**L-612 STUDENT SERVICES CENTER REMODEL COLLEGE COMPLEX**  
 BID DOCUMENTS

drawing title:  
**SS3 LOWER LEVEL DEMO PLAN - MECHANICAL**

M-0.1	MECHANICAL SYMBOL LIST & GENERAL NOTES
M-0.2	TITLE 24 - ENERGY COMPLIANCE FORMS
M-0.3	TITLE 24 - ENERGY COMPLIANCE FORMS
M-0.4	TITLE 24 - ENERGY COMPLIANCE FORMS
M-0.5	TITLE 24 - ENERGY COMPLIANCE FORMS
MD-1.1	SS3 LOWER LEVEL DEMO PLAN - MECHANICAL
MD-1.2	SS4 UPPER LEVEL DEMO PLAN - MECHANICAL
MD-1.3	ROOF DEMOLITION PLAN - MECHANICAL
M-2.1A	SS3 LOWER LEVEL FLOOR PLAN - HVAC DUCTWORK
M-2.1B	SS3 LOWER LVL. FLR PLAN - HVAC REHEAT PIPING
M-2.2A	SS4 UPPER LEVEL FLOOR PLAN - HVAC DUCTWORK
M-2.2B	SS4 UPPER LVL. FLR PLAN - HVAC REHEAT PIPING
M-2.3	ROOF PLAN - MECHANICAL
M-3.1	MECHANICAL DETAILS
M-3.2	MECHANICAL DETAILS
M-3.3	MECHANICAL DETAILS
M-4.1	MECHANICAL SCHEDULES
M-4.2	MECHANICAL SCHEDULES
M-5.1	HYDRONIC PIPING DIAGRAM
M-5.2	AIR FLOW DIAGRAM
M-6.1	MECHANICAL CONTROL DIAGRAM
M-6.2	MECHANICAL CONTROL DIAGRAM
M-6.3	MECHANICAL CONTROL DIAGRAM

drawing no:  
**M-2.1A**  
 drawing of

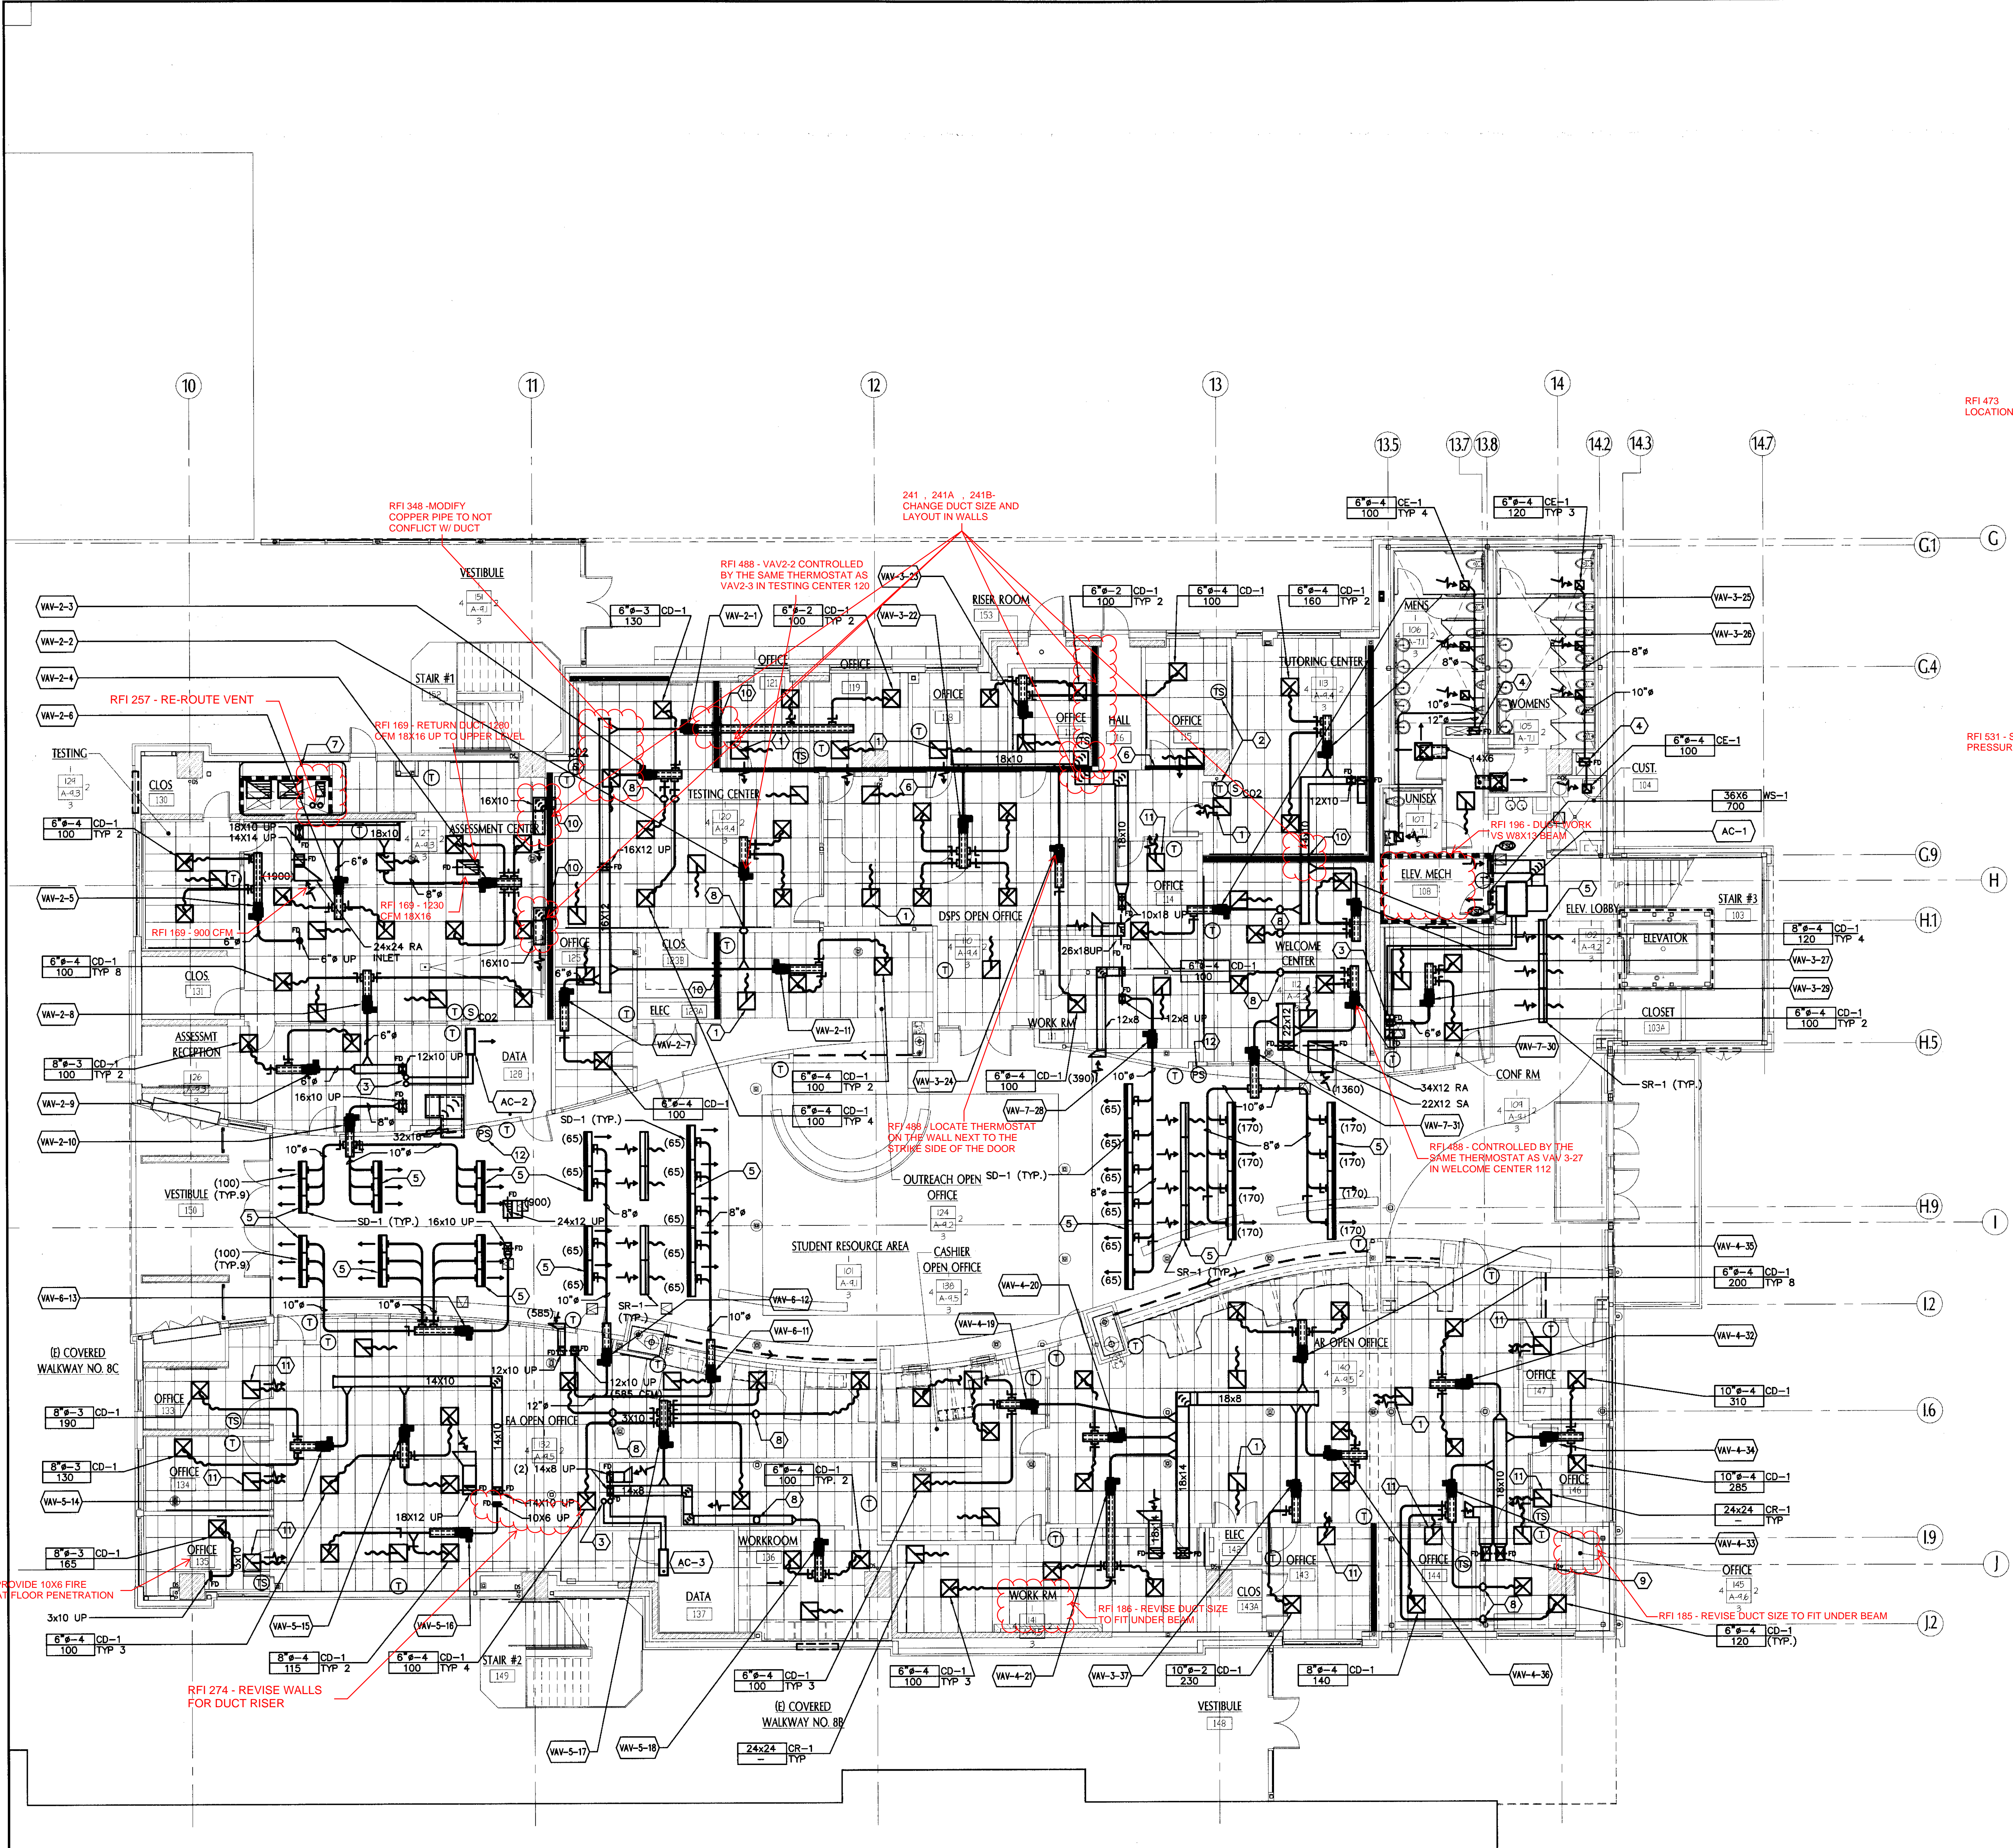
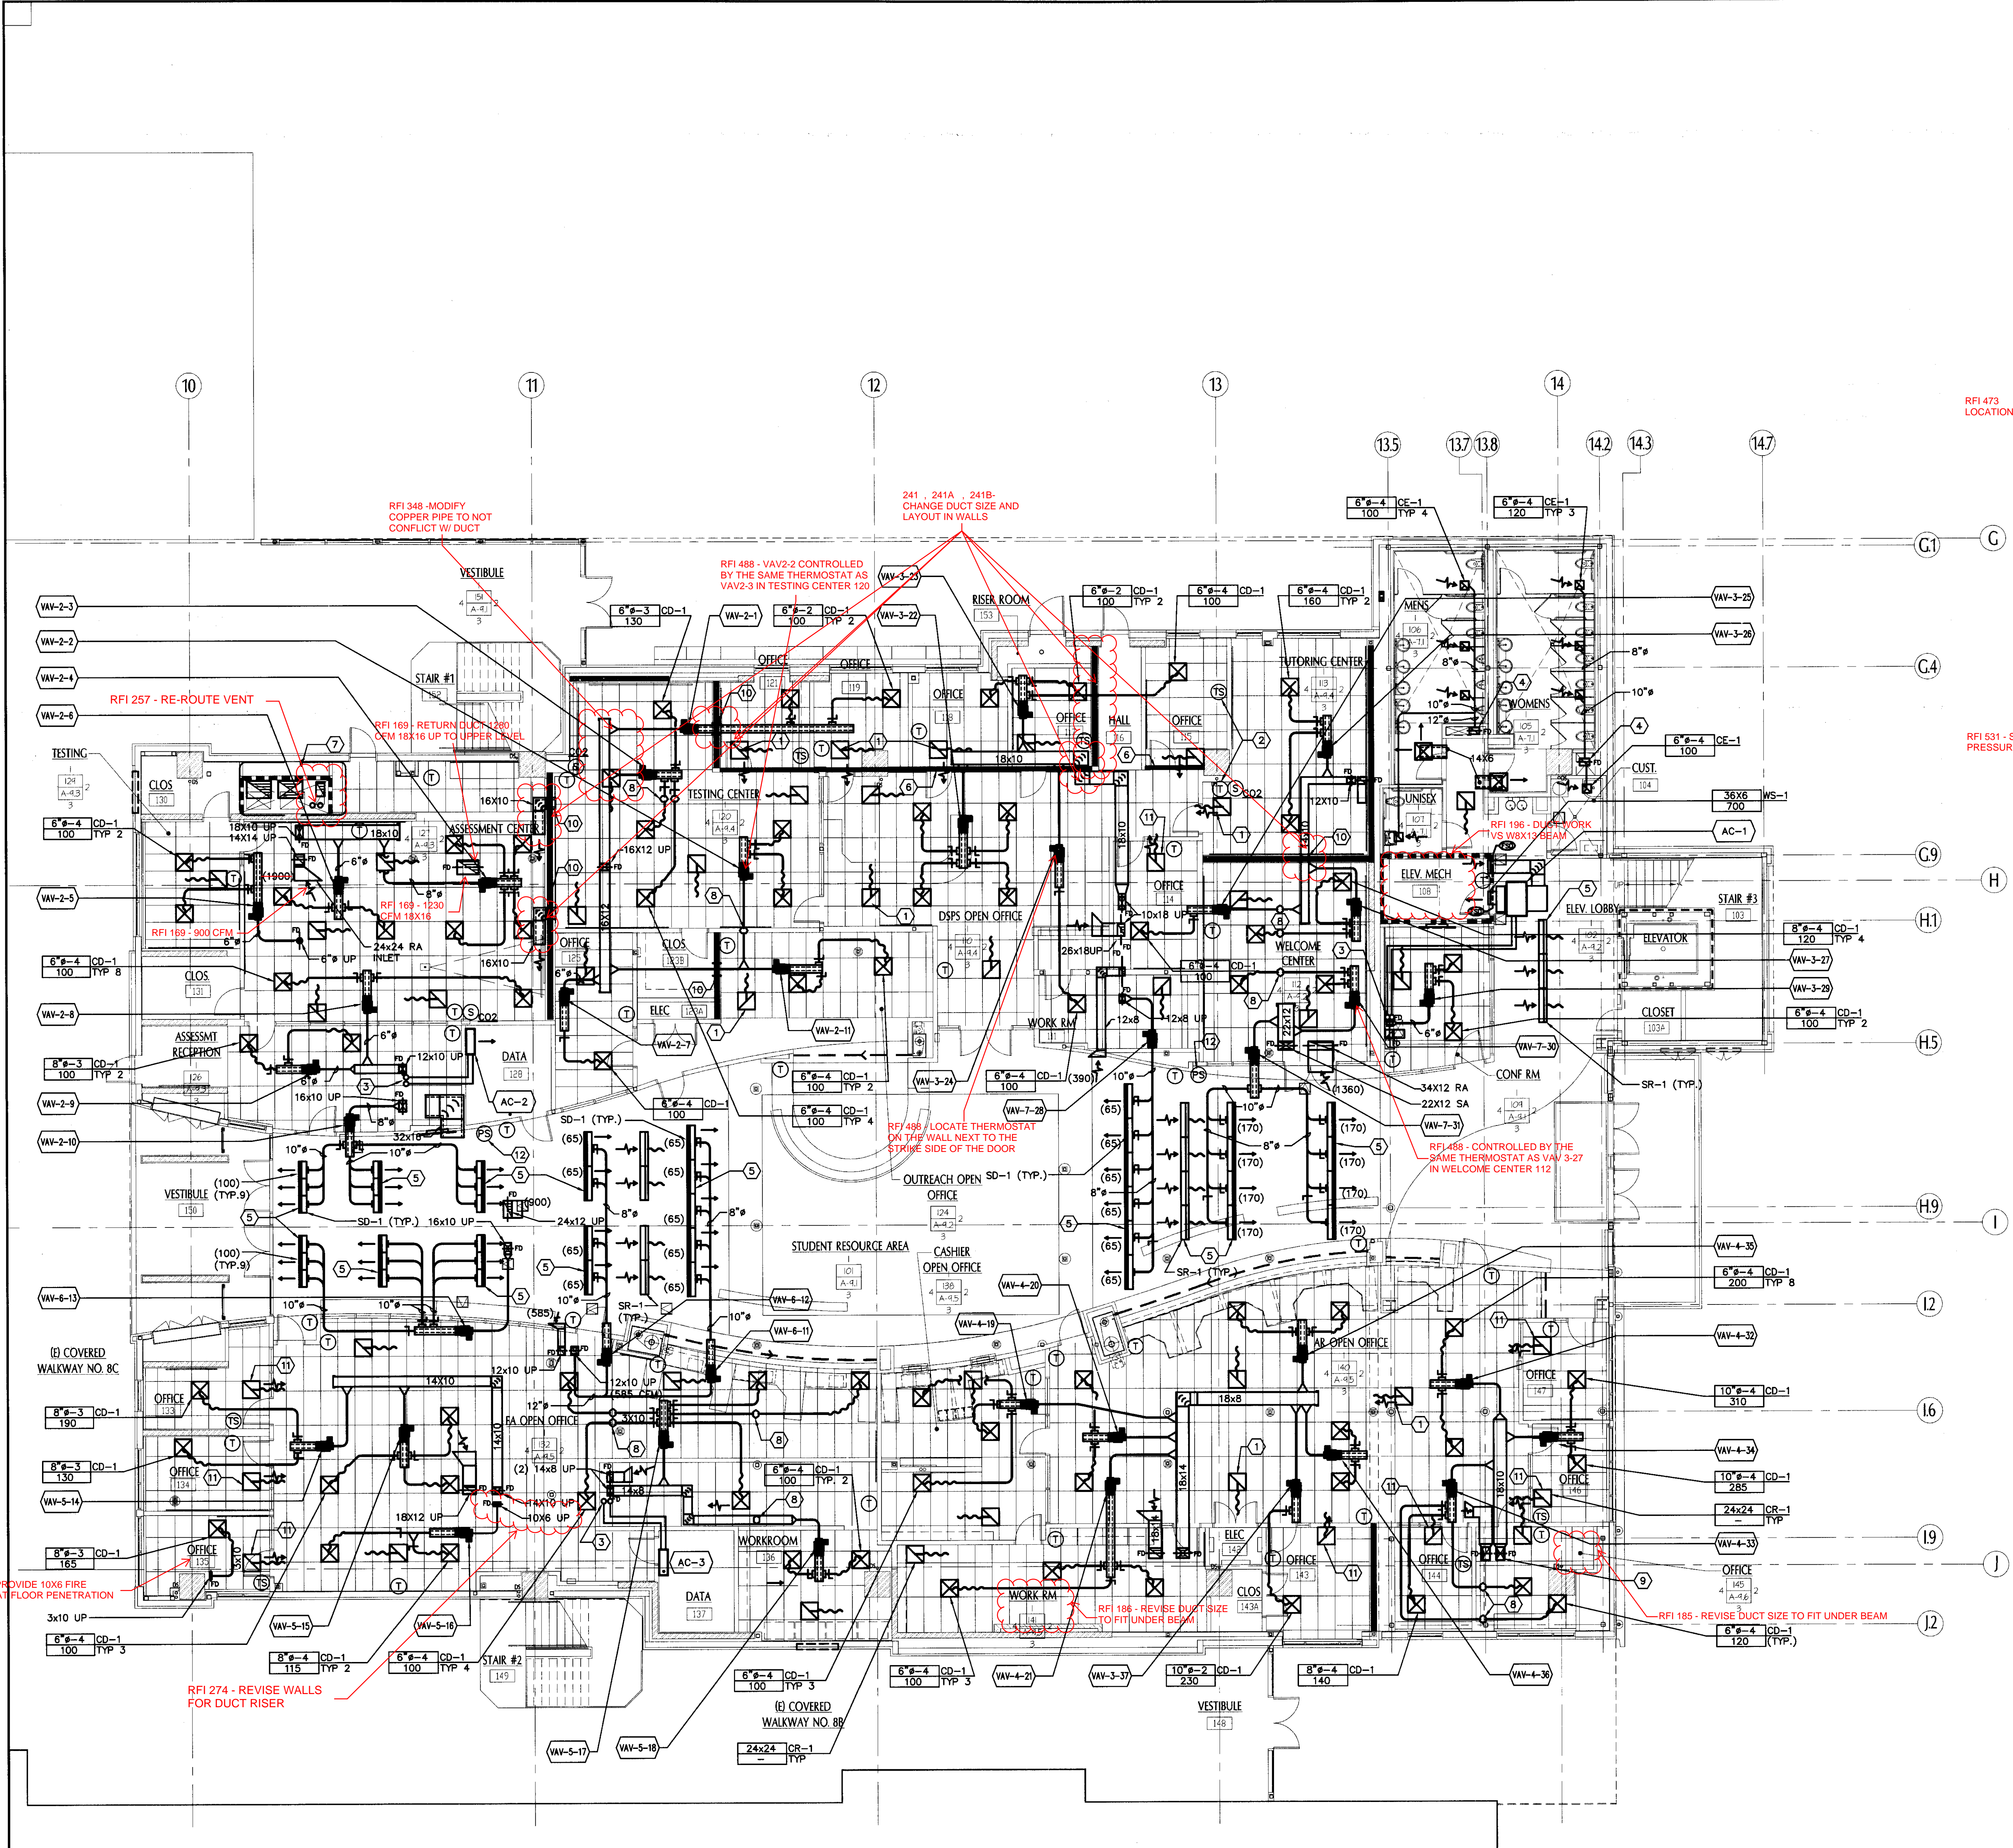
Space pressure sensor locations as indicated on sheet M2.1A.  
 - Utilize the sensor location on the west side of the building to control AHU 1, 2, 5, & 6.  
 - Utilize the sensor location on the east side of the building to control AHU 3, 4, & 7.

RFI 626 - AIRFLOW DISCREPANCIES (ROOM 231, VAV 2-2, VAV 2-32, VAV2-11, VAV 4-32, VAV 5-4)
